### DESIGN REVIEW STAFF REPORT – SINGLE FAMILY

**1434 E. Maple Street**  
*Address*

**PADR-000877-2023**  
*Case Number*

# Maple Street - 2 Unit

PROPOSED SITE PLAN

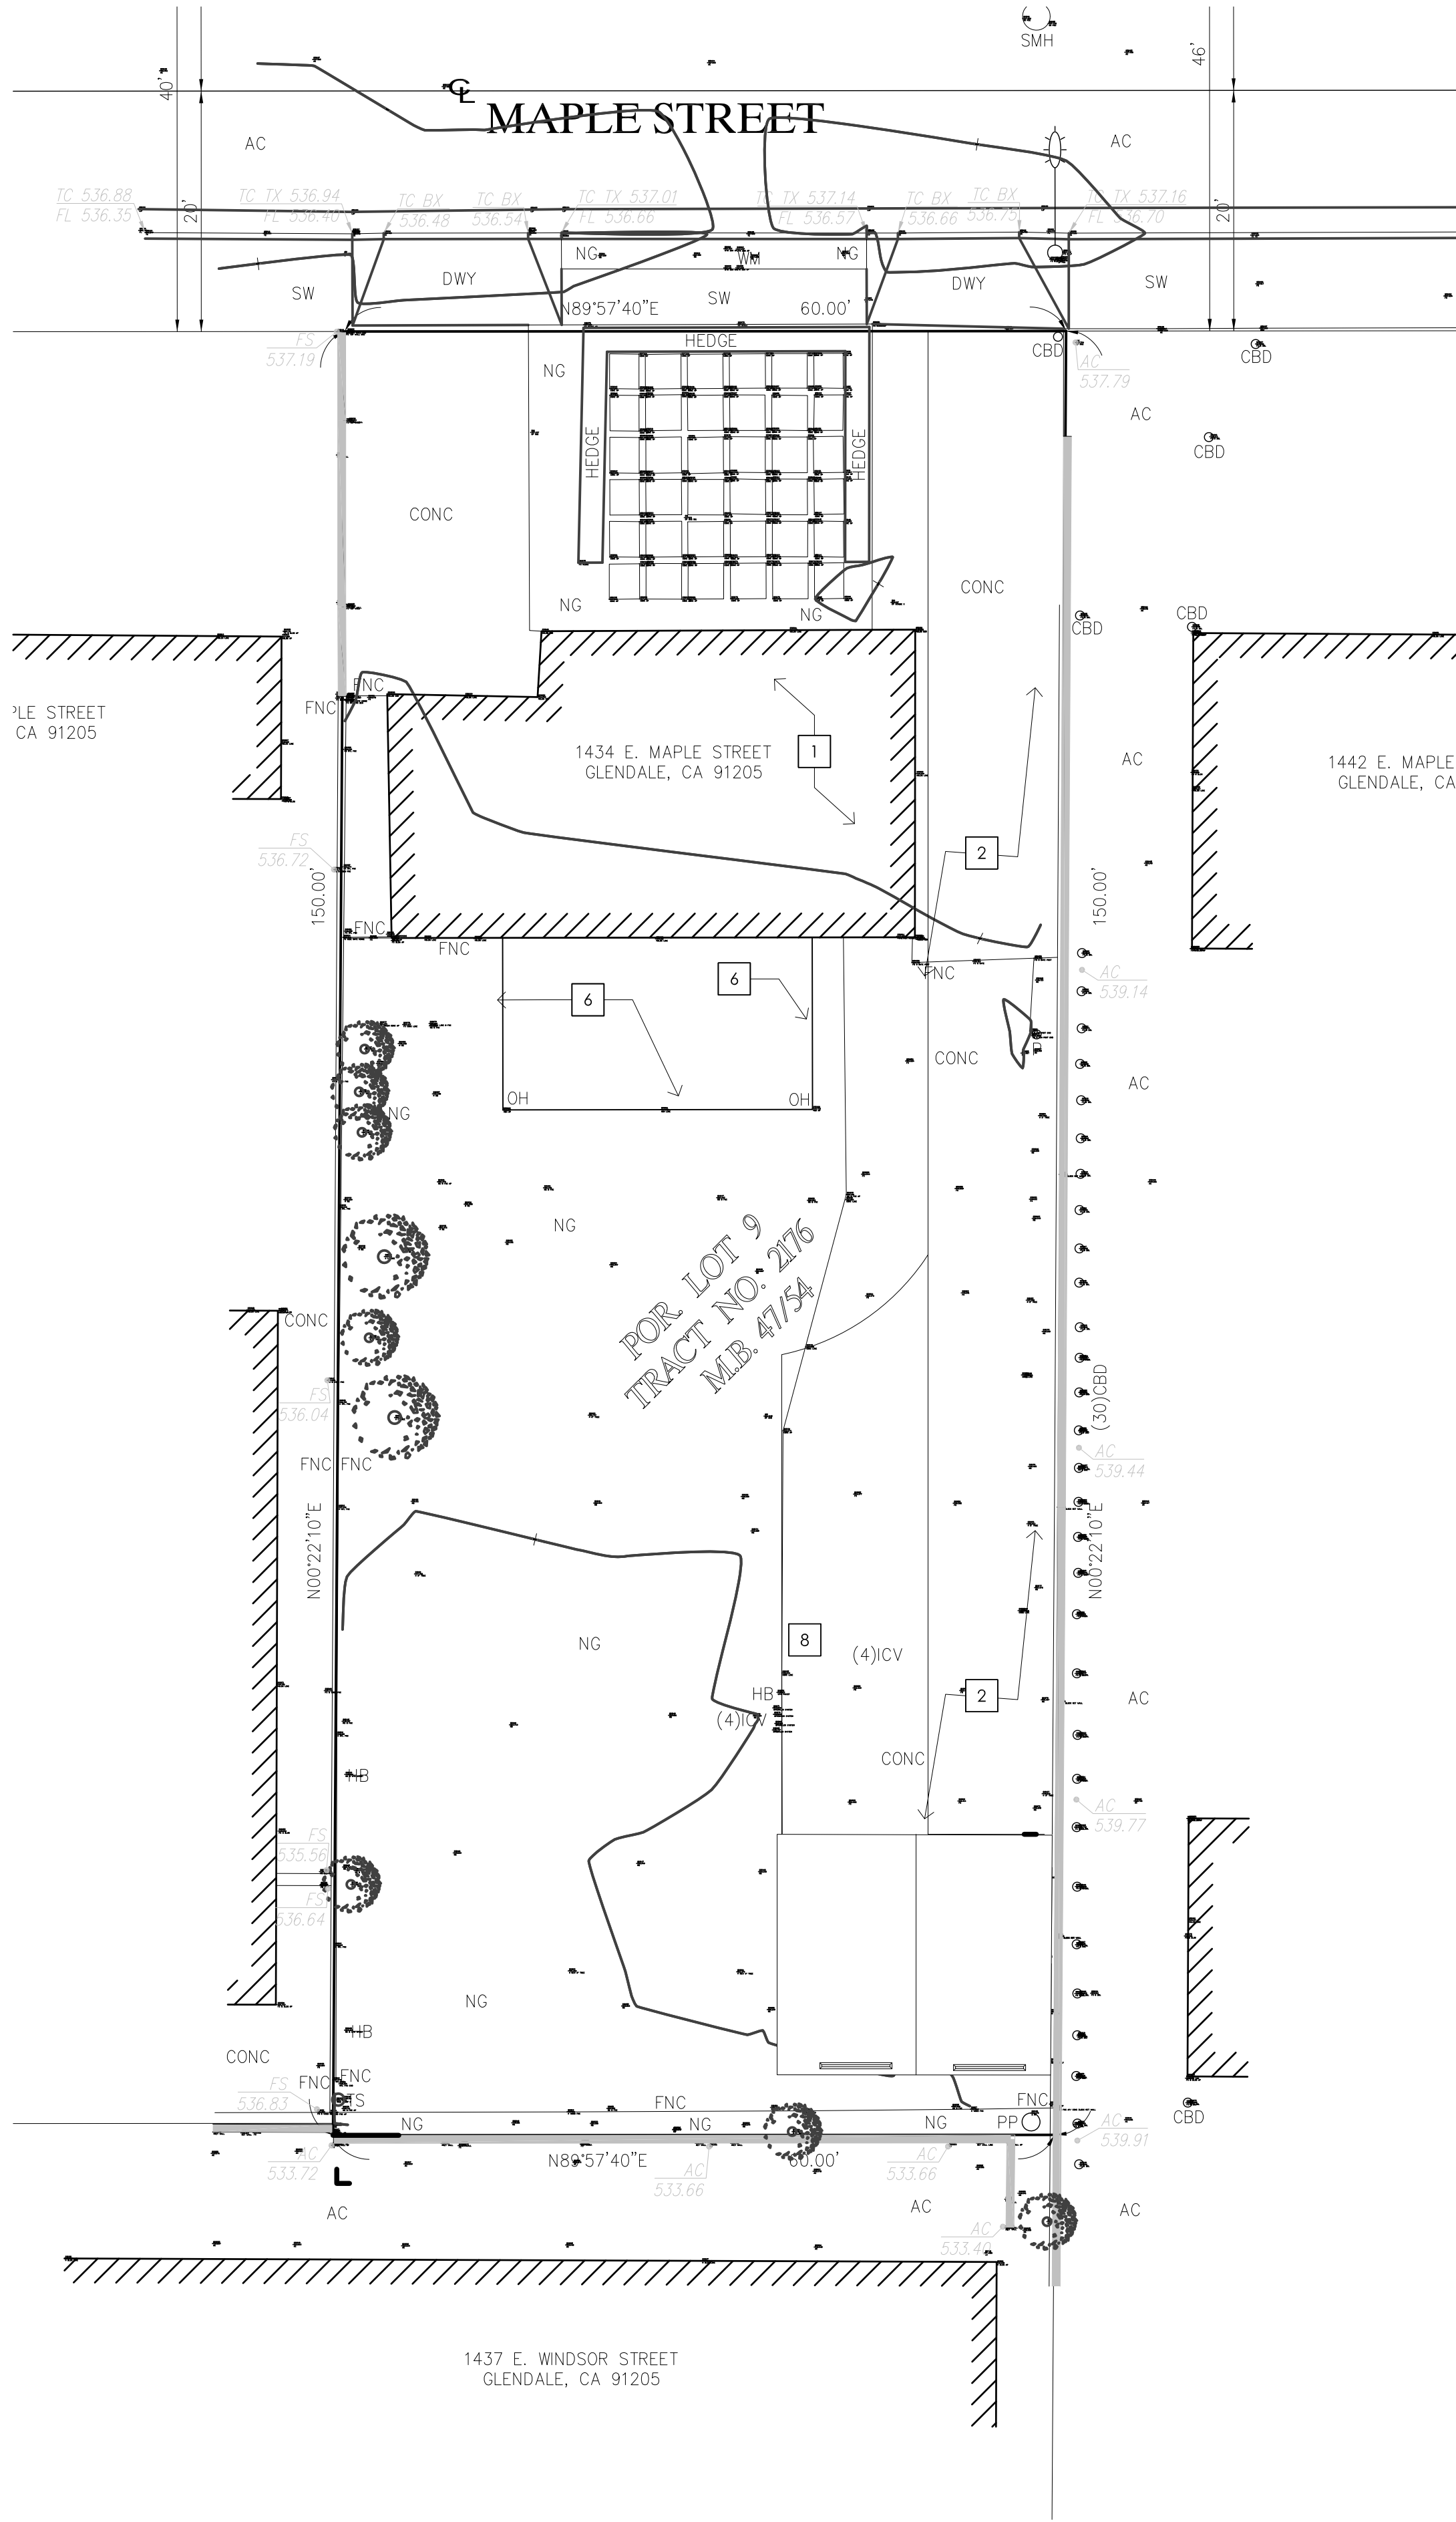
Access to the new the garage is provided from an existing concrete driveway that is accessed from E. Maple Street. As a consideration, the concrete driveway should incorporate decorative paving elements (such as brick, stone, stamped concrete) to enhance the appearance viewed from the street.

## ROOF PLAN

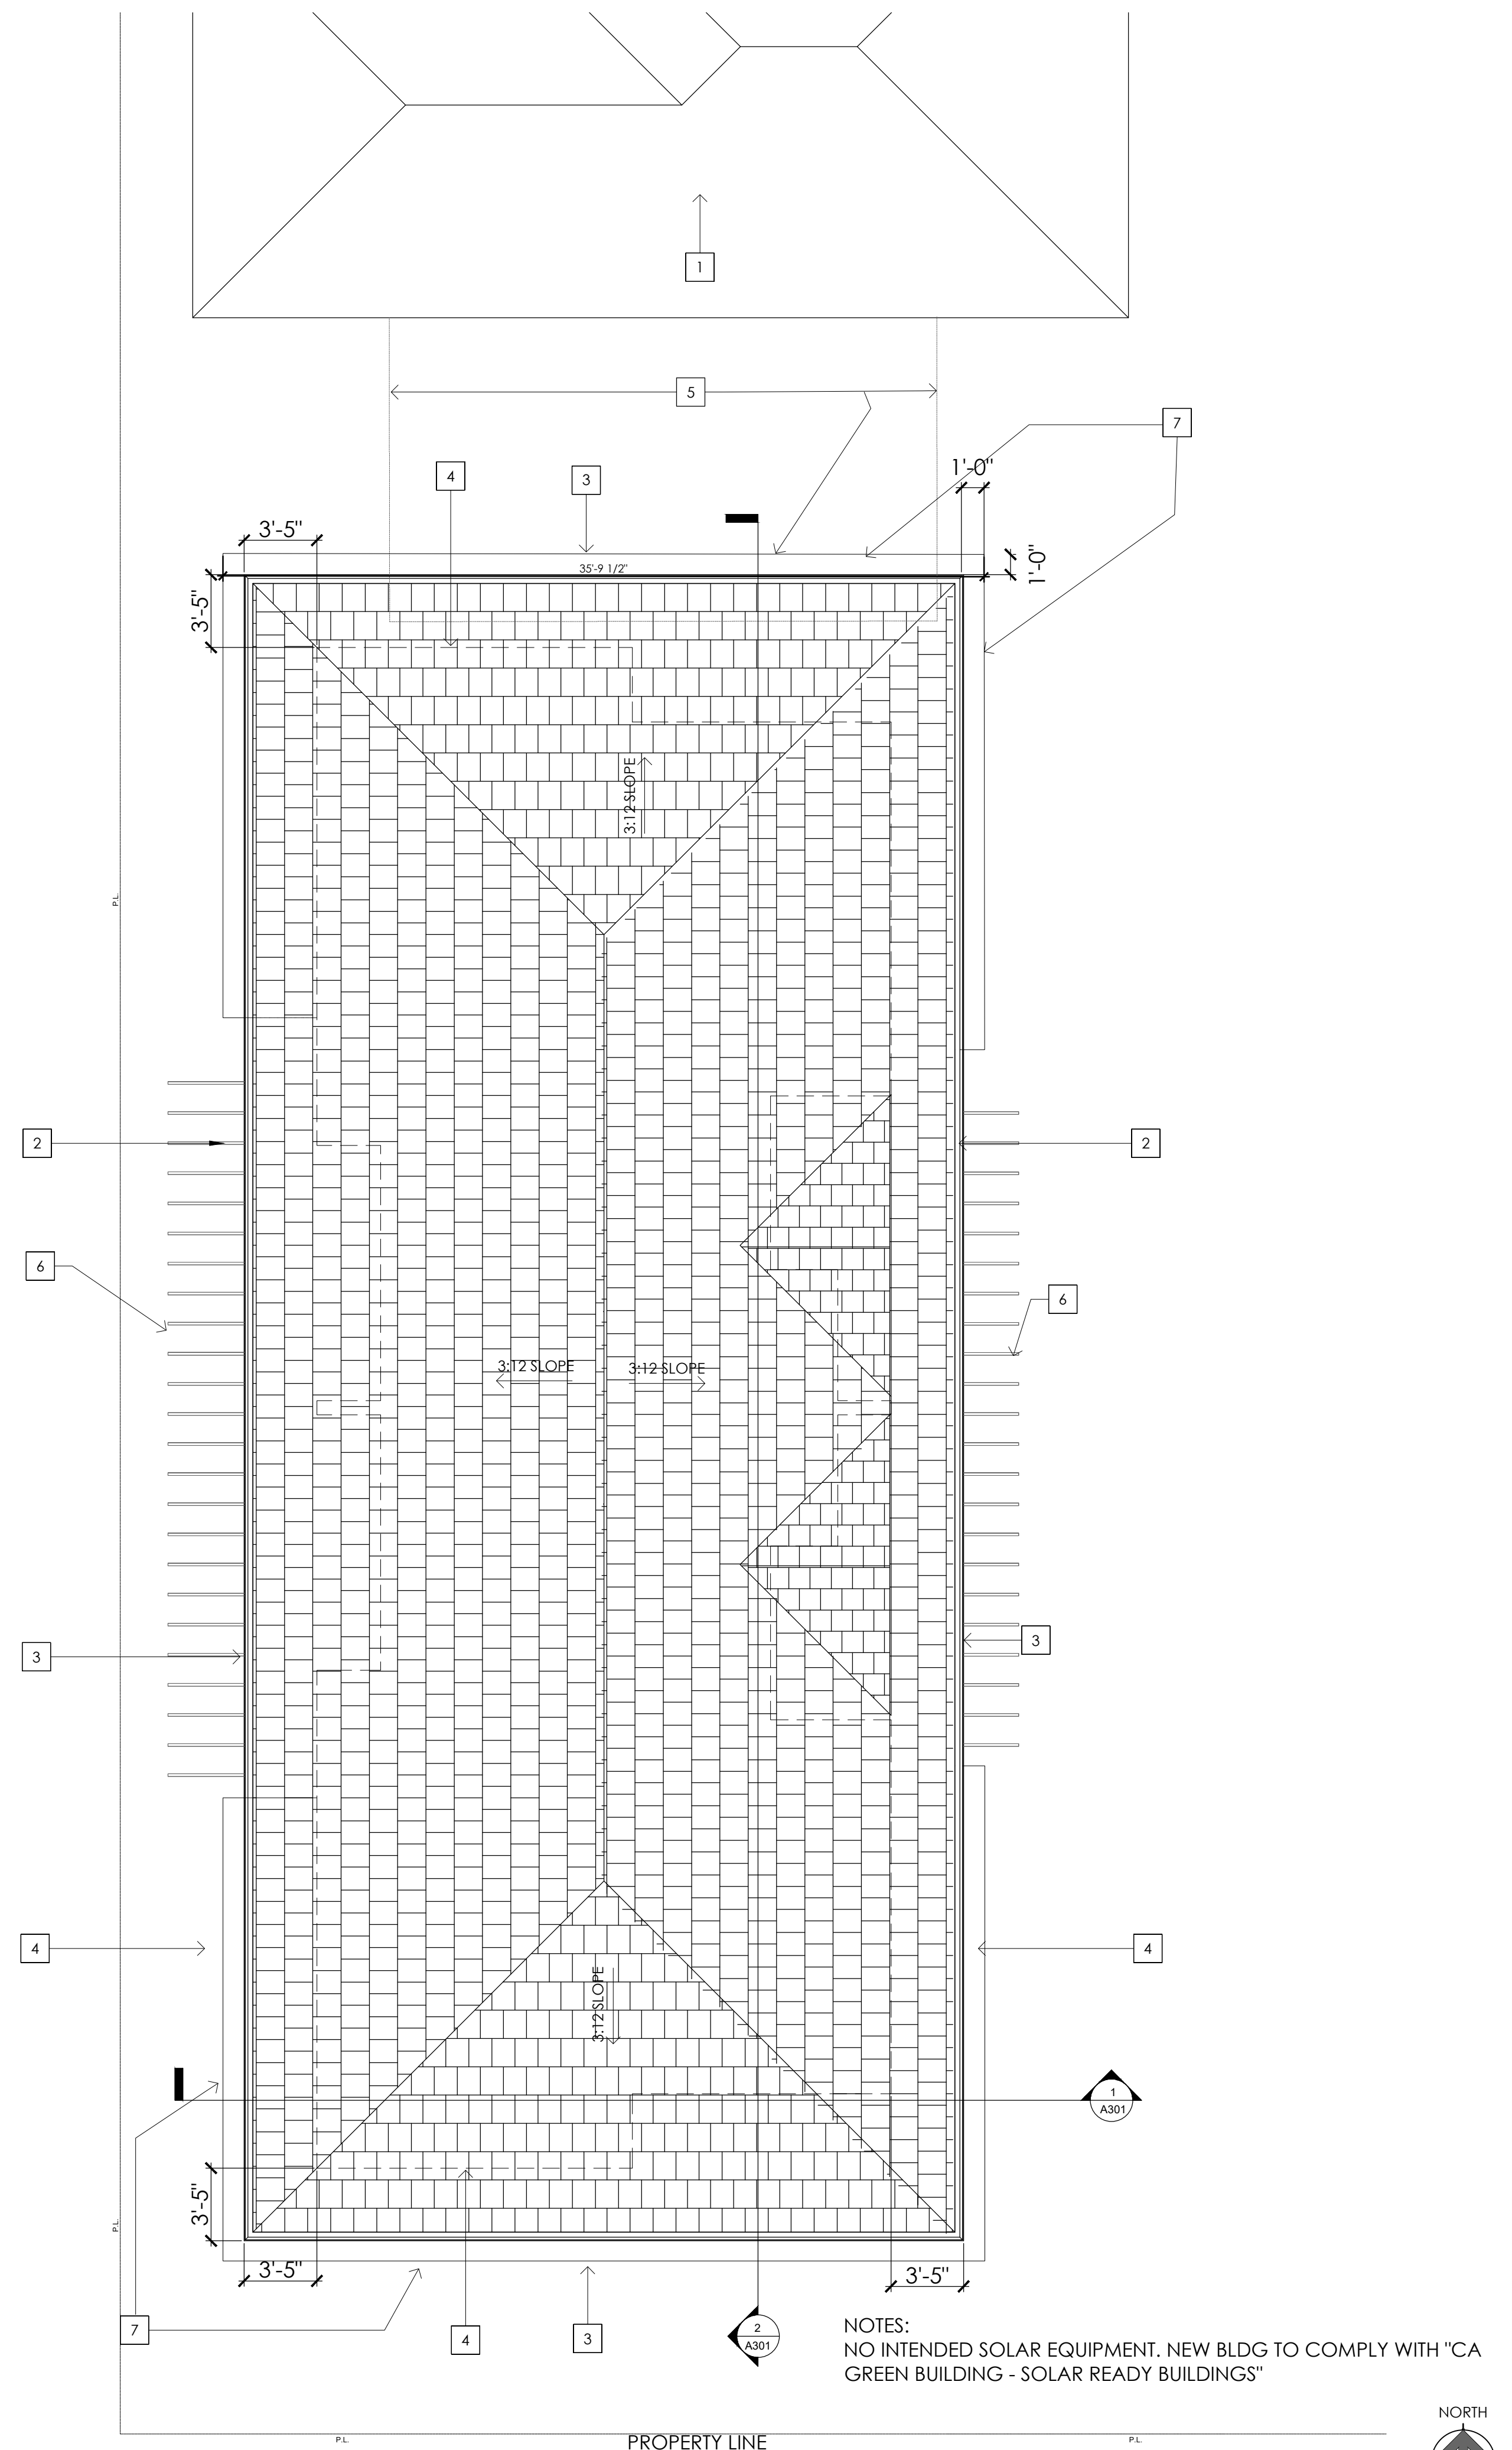
For better design integration, a condition is included to revise the roof plan to ensure that all roof eaves have the same depth and consider adding layers to the roof form to be more consistent with the primary dwelling, removing the tacked-on gables above the patios if necessary. And bring the roof on the first-story all the way to the second-story balconies for a more natural flow.

1. Revise the roof plan to ensure that all roof eaves have the same depth and consider adding layers to the roof form to be more consistent with the primary dwelling, removing the tacked-on gables above the patios if necessary. And bring the roof on the first-story all the way to the second-story balconies for a more natural flow.
2. That specifications (cut sheets) for the exterior lighting fixtures on the new building and locations shall be submitted to staff for review and approval prior to plan check submittal. The exterior lighting should be appropriate to and consistent with the style of the new building; limit their location to the main entry and patio doors.
3. Paint the gutters to match the adjacent wall color.
4. That all new fences/wall/gates be clearly shown on the plans for staff review and approval prior to plan check submittal.
